Service Bulletin

LIGHTWEIGHT, HIGH-SPEED, VERTICAL VIBRATION RECOVERY AND MITIGATION

NOTICE No.: 33000-6R2
DATE: 19 September 2025
Page **5** of **5**

Figure 1. Vertical Hop Flight Envelope

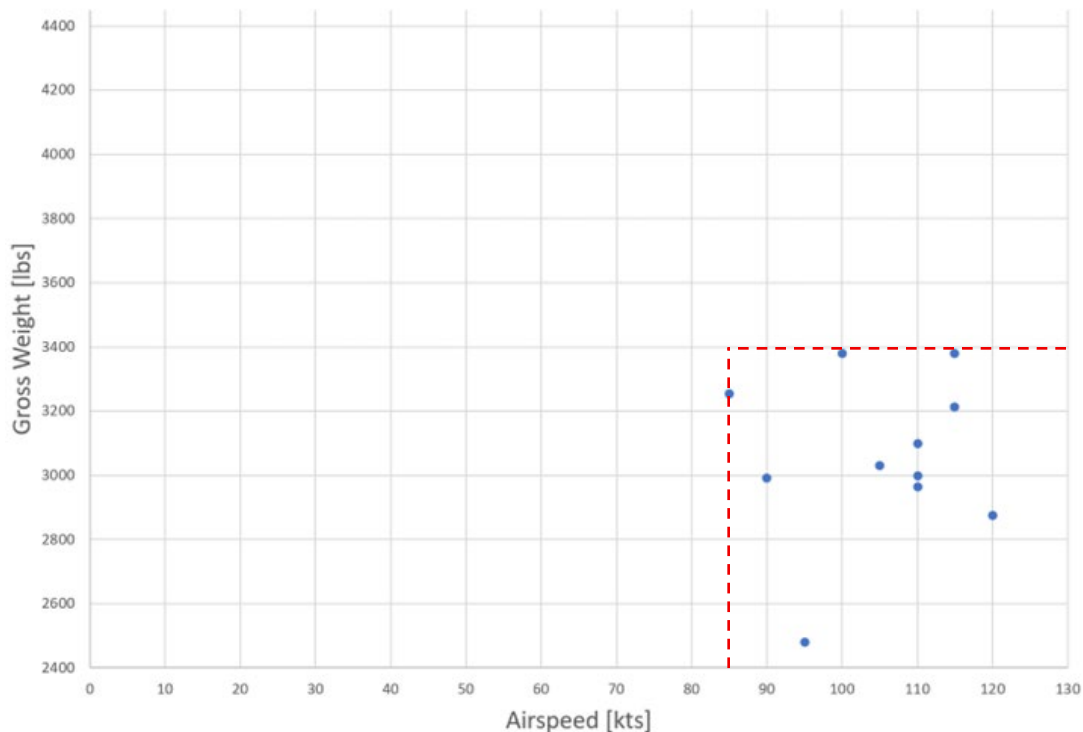
As of the date of publication, this phenomenon has been reported on only 15 aircraft since 2019. All have landed safely. One instance resulted in damage to the aircraft due to the pilot being unaware of the proper recovery resulting in prolonged vibration. All reported instances have been less than 3,400 lbs gross weight, typically with a single pilot and low fuel (see Figure 1). Of the nearly 300 aircraft in service with 20633000-101 main rotor blades, the vast majority (~95%) have never experienced this issue.

If a vertical vibration develops in forward in-flight, immediately reduce speed and load the rotor by increasing collective.

Note the intensity, air speed, and fuel level at the time of occurrence. Continue flight at reduced speed. Approximately 5-10 KIAS below the speed at the onset of the vibration is typically sufficient to avoid recurrence.
